Service Bulletin

NO. 358

SOUTH BEND 27, INDIANA

Fig. 1

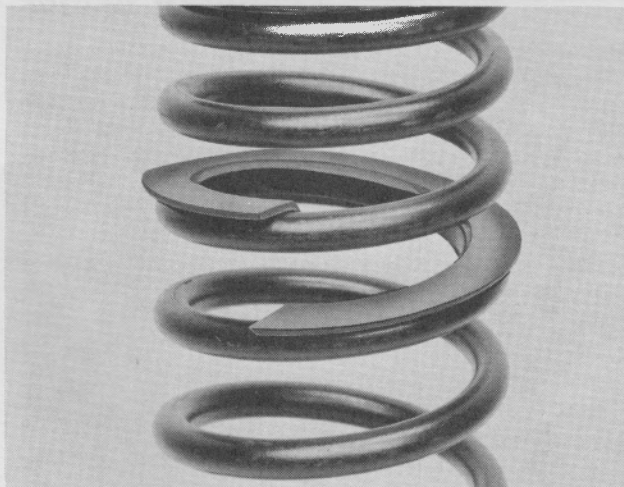
The installation of rubber Insulator, Part No. 526249, between the coils of the front spring will eliminate noise caused by coil-to-coil contact of the front spring which sometimes occurs under light load conditions.

Place the rubber insulator on top of the center coil with the inner flange of the insulator down (See Fig. 1) and then thread the insulator upward as far as possible. The weight of the car will hold the insulator in place. In some instances, it may be necessary to install two insulators to completely eliminate spring interference noise. The second insulator is installed in the same manner, and positioned adjacent to the first insulator.

FIG. 3

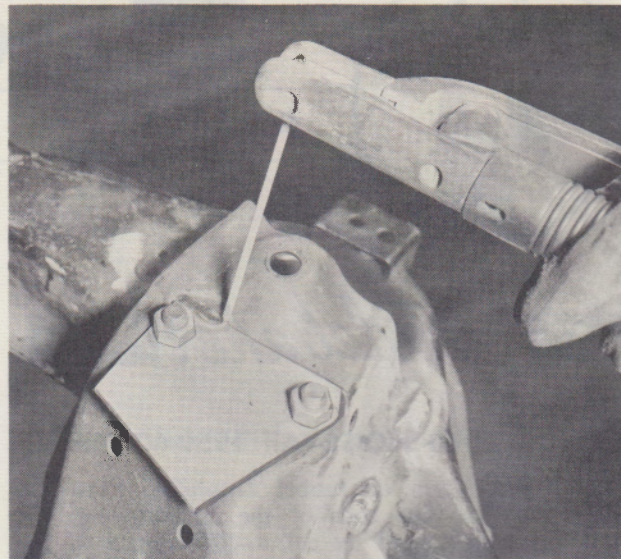
1. Remove the upper control arm pivot shaft.
2. Bolt the re-inforcing plate to the crossmember as shown in Fig. 2.
3. Arc weld the plate to the crossmember as shown in Fig. 3. Continue the weld around the part of the plate that sits flat on the crossmember.
4. Bend the remaining part of the plate down so that it will fit tight against the crossmember.
5. Continue the arc weld around the remaining portion of the plate. (See Fig. 4).
6. File the area of the re-inforcing plate on which the pivot shaft will be bolted as indicated in Fig. 5.
7. Install upper control arm pivot shaft.

FIG. 2

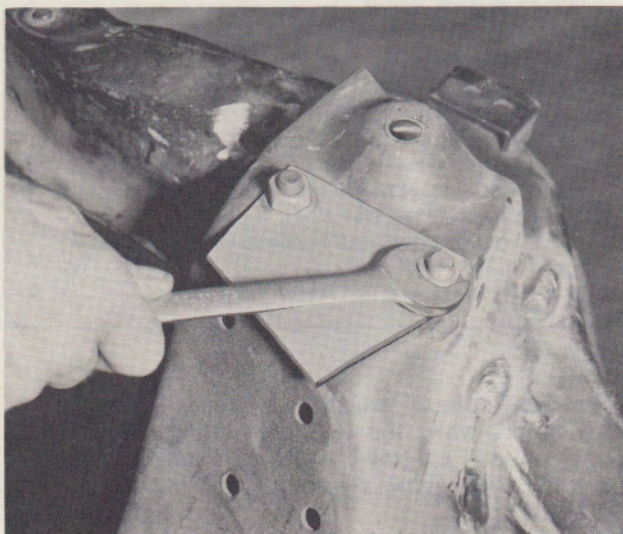
We have received some field reports of front crossmembers cracking in the area of the upper control arm pivot shaft. In each instance the cars involved are used in severe type service and the cracking occurred at comparatively high mileages.

When this condition does occur, a field repair can be made by installing a re-inforcing plate, Part No. 1553491. The plate is available from your Parts Depot. The re-inforcing plate must be installed in the following manner:

FIG. 6

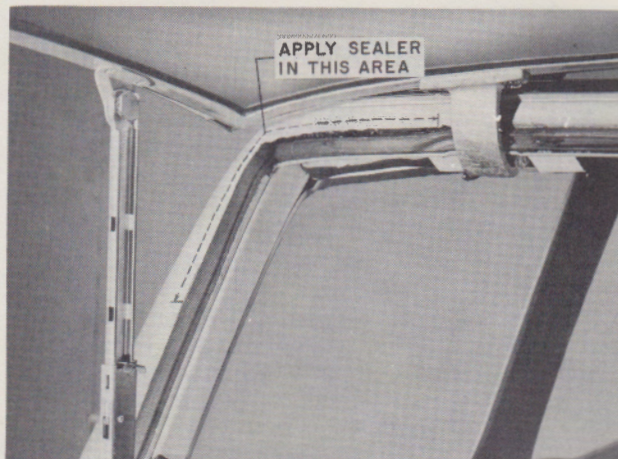
Sealer is now being applied in production to the upper corners of the tail gate weatherstrip channel between the rubber weatherstrip and the outer edge of the channel. The sealer is applied after the weatherstrip is installed and prevents water from running behind the weatherstrip.

Apply a bead of Studebaker-Packard Weatherstrip Cement, Part No. SP-50045, between the rubber weatherstrip and the outer edge of the channel. The sealer should extend from the upper hinges to the corners, and then downward for a distance of approximately 5 inches. (See Fig. 6).

FIG. 8

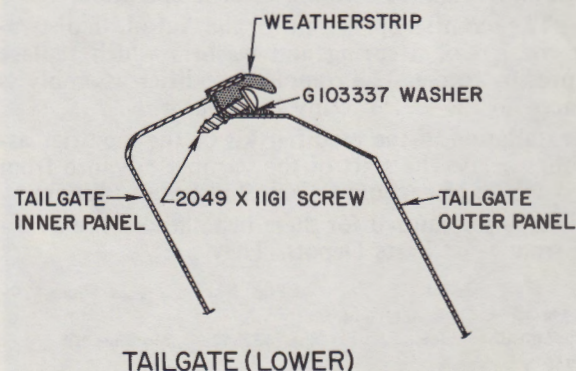
A small screw and washer is now used to retain each end of the lower gate-to-upper gate rubber weatherstrip. The screws and washers are installed after the rubber is cemented to the gate.

1. If the rubber weatherstrip is loose, cement it firmly to the gate being certain the end sections of the rubber are properly located and cemented to the channel and to the end surfaces of the gate.
2. Punch or drill a 7/64" hole thru the rubber weatherstrip and thru the outer panel of the tail gate channel at the lower intersection of the vertical and horizontal section of the outer panel 1 1/4" from the outer end of the gate. (See Fig. 7).
3. Install the small screw, Part No. 2049 x 11G1—(No. 6—18 x 3/4 truss head) and flat washer, Part No. G103337 (5/32 x 3/8) in the punched hole and tighten the screw securely. (See Fig. 8).
4. Repeat steps 2 and 3 at the opposite end of the gate.

FIG. 9

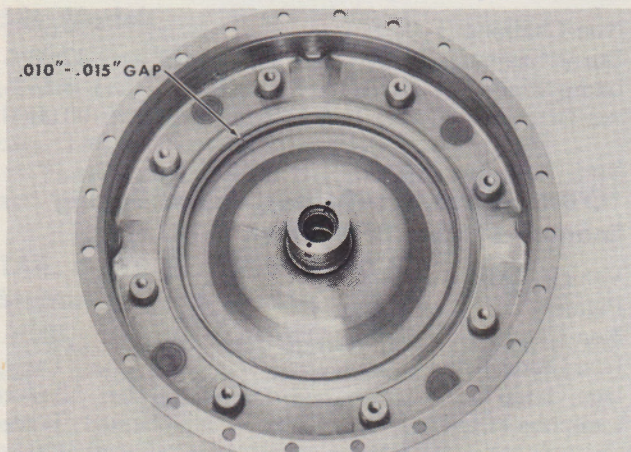
This malfunction may be caused by piston rings that are butting because of insufficient ring gap. It is recommended that all piston rings be checked for gap before installation. Each of the four outer rings should be checked for gap in the bore of the clutch housing. (See Fig. 9). File the ends as necessary to provide a gap of .010" - .015". Clean off all burrs or roughness caused by filing. Upon installation, make sure ring gaps are spaced so that no two gaps are in line.

FIG. 10

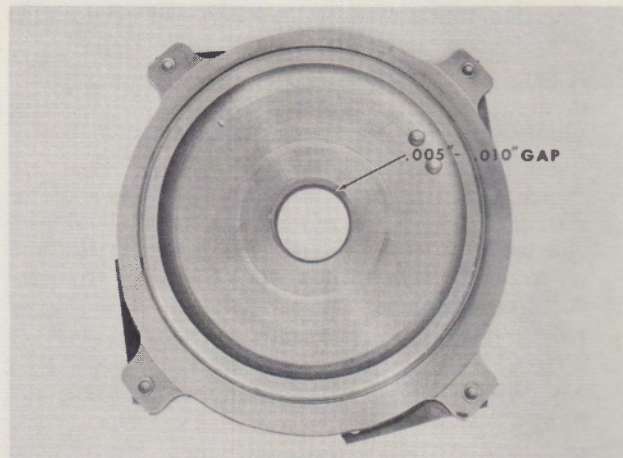
To check the inner ring, insert the ring into the bore of the piston and check the gap as shown in Figure 10. The ring gap should be .005" to .010". Remove any burrs or roughness caused by filing if it is necessary to file the ring to provide a gap within the prescribed limits.

FIG. 11

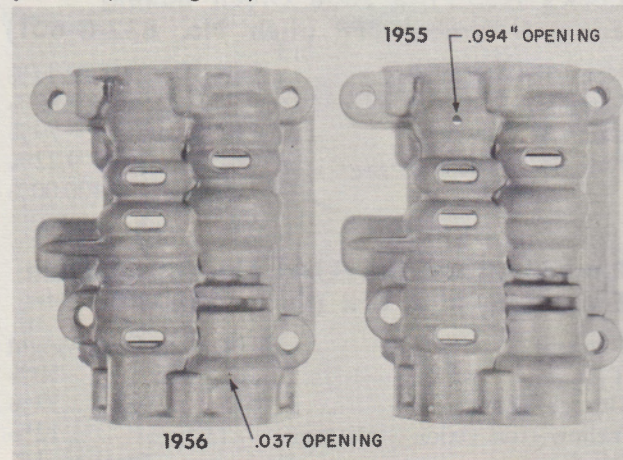
The 1955 assembly has a .094" vent opening, drill size No. 42, over the direct shift valve in the rear upper valve body. (See Fig. 11).

The 1956 valve body assembly has a .037" vent, drill size No. 63, located over the low high shift piston. (See Fig. 11).

FIG. 12

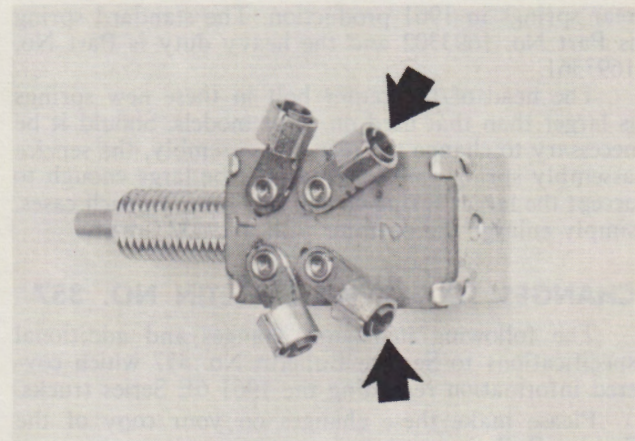
We have received a few complaints regarding the automatic transmission down-shifting on light throttle application. In each instance it has been found that the wires to the kick-down switch were placed in the wrong terminal.

The correct method of connecting the kick-down switch on the 4E and 5E Series trucks is shown in Fig. 12.

FIG. 13

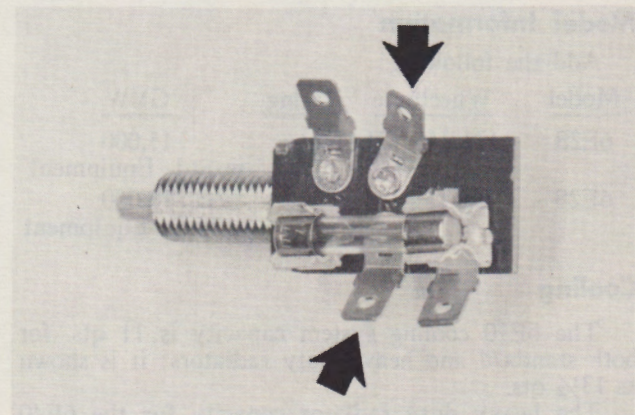
Beginning with Serial Nos. E7-13801 and E12-4701 (6E Series), a new kick-down switch is used. Fig. 13 shows the correct terminals to use on the new switch.
